Access Compliance Report Public Rights-of-Way (Curb Ramps)

Main Street: BAINBRIDGE_AVE		Cross Street: ROYCROFT_CT		Location:	SE
ADA ID: RPRK211115120337	Ramp Type: Type 4 - Parallel	Initial Pass/Fail: Fail	Overall Compliance: No	Severity Score:	2
Codes/Mitigation Info/Possible Solution			Field Measurements/Component Compliance

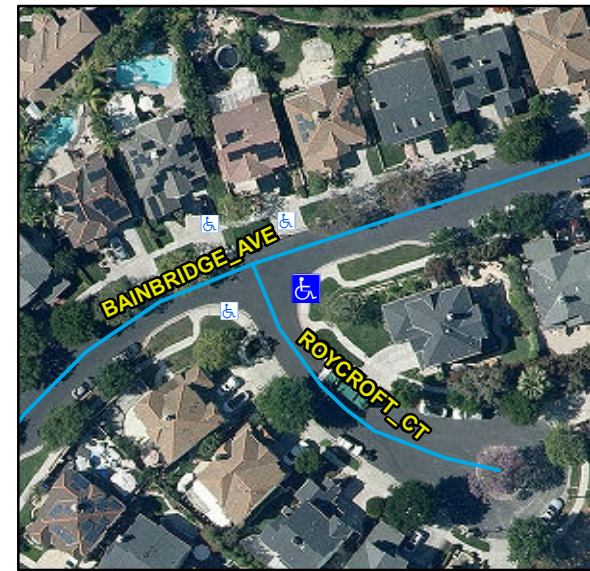
Compliance	Description	Data	Compliance	Description	Data
N/A	Ramp Length LT (in)	146	N/A	Ramp Length RT (in)	139
Yes	Ramp Width LT (in)	54	Yes	Ramp Width RT (in)	54
Yes	Ramp Run Slope LT (%)	7.7	Yes	Ramp Run Slope RT (%)	0.7
No	Ramp Cross Slope LT (%)	2.2	No	Ramp Cross Slope RT (%)	3.6
N/A	Landing Present	N/A	N/A	DWS Provided	N/A
N/A	Landing Length (in)	N/A	N/A	DWS Contrast	N/A
N/A	Landing Width (in)	N/A	N/A	DWS Length (in)	N/A
N/A	Landing Run Slope (%)	N/A	N/A	DWS Full Width	N/A
N/A	Landing Cross Slope (%)	N/A		DWS Offset Type	N/A
N/A	Landing Movement Obstructed?	N/A	N/A	DWS Offset Left (in)	N/A
	Landing Movement Type	N/A	N/A	DWS Offset Right (in)	N/A
N/A	Landing Shared	N/A			
N/A	Clear Space	Yes			
N/A	Clear Space To Crosswalk (in)	N/A			
N/A	Marked Crosswalk 1	No	N/A	Marked Crosswalk 2	No
	Crossing 1 Direction	N		Crossing 2 Direction	W
	Marked Crosswalk 1 Width (in)	N/A		Marked Crosswalk 2 Width (in)	N/A

Remove & Replace Curb Ramp With Two New Directional Ramps or Equivalent.
